MMDS and MMEVS Changes for MC68HC908ASxxA, MC68HC908AZxxA, and MC68HC908AB32

EB387/D

Figure 1. Emulation Board Configured for AZ/AS/AB (Original Design)

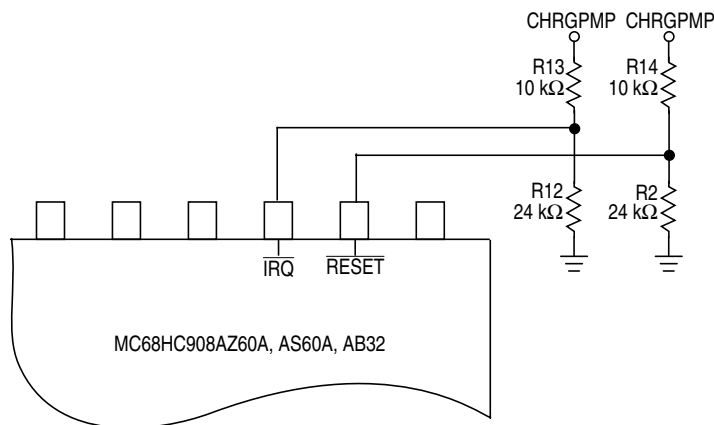
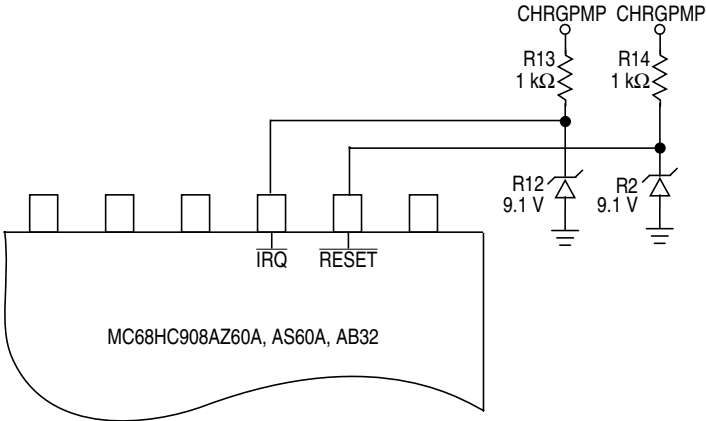
Two pins ($\overline{\text{IRQ}}$ and $\overline{\text{RESET}}$ on the M68HC08 Family of MCUs) have special three-state input functions to allow either special modes to be entered or for disabling the COP watchdog timer. The new 0.5- μ devices have slightly different input structures to detect a higher voltage input on the $\overline{\text{IRQ}}$ and $\overline{\text{RESET}}$ pins than the older devices. A component change on the board is necessary to ensure consistent operation on the MMDS08. **Figure 1** shows the old and new circuits.

Figure 2. Emulation Board Configured for AZ/AS/AB (Modified Design)
